Revisions:
1. 6/18/15 REVISED PER CED REVIEW COMMENTS

Storm Drainage Revision
Lakewood Ridge
City of Charlotte, Mecklenburg County, North Carolina
LGI HOMES, 2670 S. Tryon St., Ste F, Charlotte, NC 28207

ENGINEERING
PCO / DETENTION / DRAINAGE PLAN

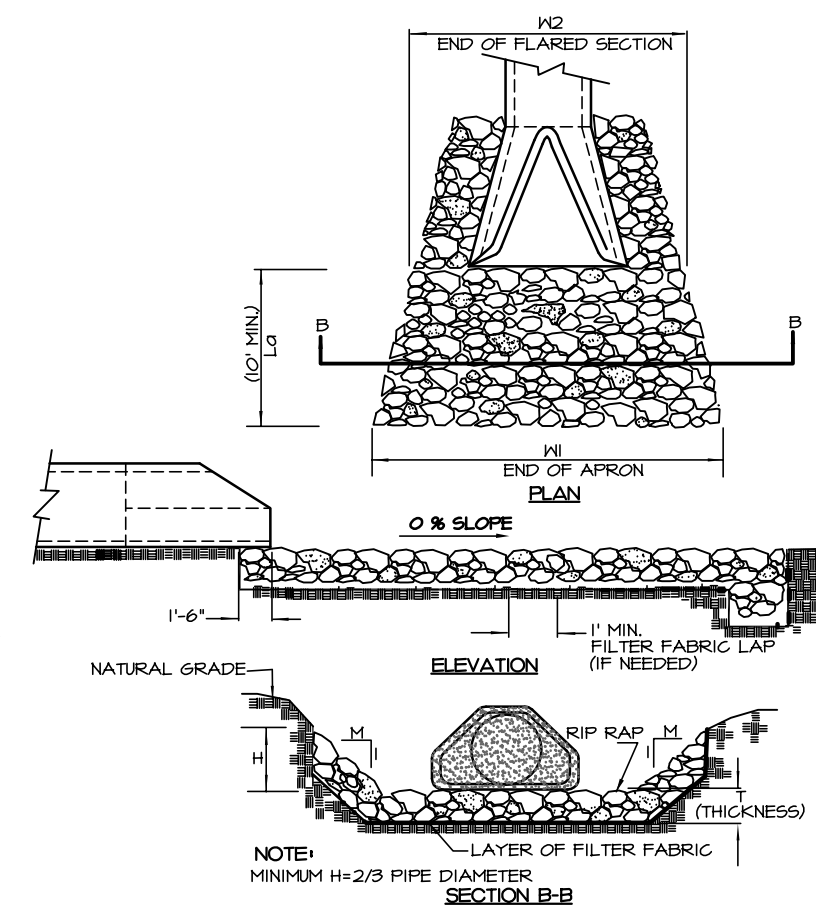
1. THE PURPOSE OF THIS REVISION IS TO ALLOW FOR AN OVERFLOW FROM Y11 TO FLOW IN THE EXISTING DITCH TO HW 17 TO ACCOMMODATE THE VOLUME THAT CANNOT BE HANDLED IN THE EXISTING STORM PIPE FROM Y11 TO MH 2. HW 17 TO FES 18 WILL BE REMOVED AND UP-SIZED FROM A 24" RCP TO A 30" RCP. NO LOTS OR ROADWAYS HAVE BEEN AFFECTED BY THESE REVISIONS.

FROM	TO	SLOPE	LENGTH	DIA.	STRUCTURE	FROM	STRUCTURE TO
(1)	(2)	(3)	(4)	(5)	(6)	(7)	(8)
Y11	FES 18	2.00	8.00	24	690.86	698.57	698.41
HW 17	MH 18	3.00	8.0	30	664.00	668.0	663.76
MH 18	FES 19	1.20	88.0	30	659.86	658.72	658.72
